STATE OF UTAH DEPARTMENT OF NATURAL RESOURCES DIVISION OF OIL, GAS AND MINING						FORM 3 AMENDED REPORT				
<b>APPLICATION FOR PERMIT TO DRILL</b>						1. WELL NAME and NUMBER Hadden 7-29-3-1W

**Newfield Production Company**  
**Hadden 7-29-3-1W**  
**SW/NE Section 29, T3S, R1W**  
**Duchesne County, UT**

# Application for Permit to Drill Statement of Basis

### Permit To Drill

## Casing Schematic

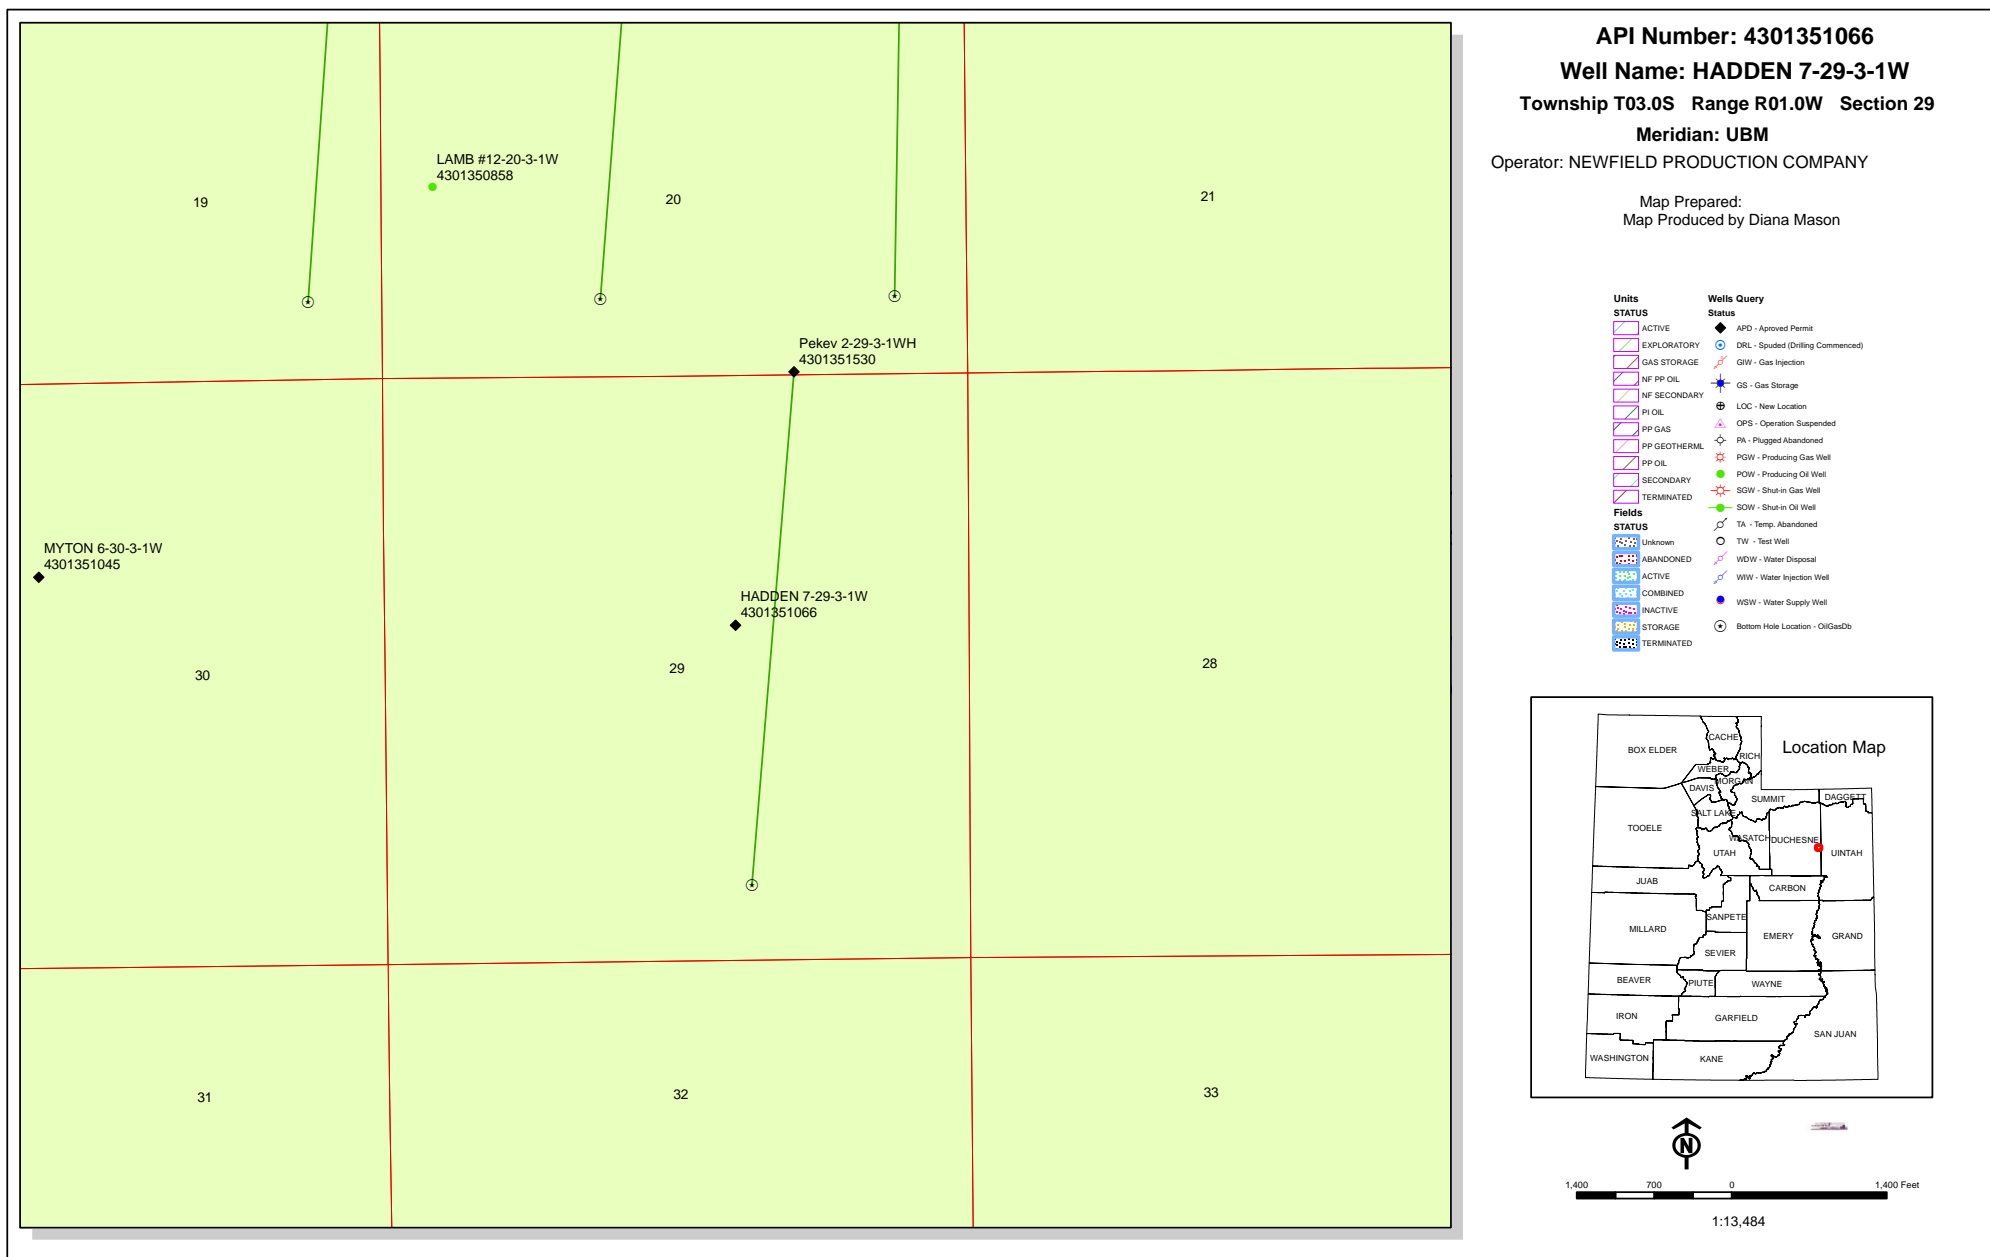
TOC @ 940 - 1222' BMSW (Newfield)  
1250 ± BMSW

TOC @ 3445.

to 2124' @ 5% w/o, tail 5864'

propose to 2000'

Cement volume for the 5 1/2" production string shall be determined from actual hole diameter in order to place cement from the pipe setting depth back to 2000' MD as indicated in the submitted drilling plan.
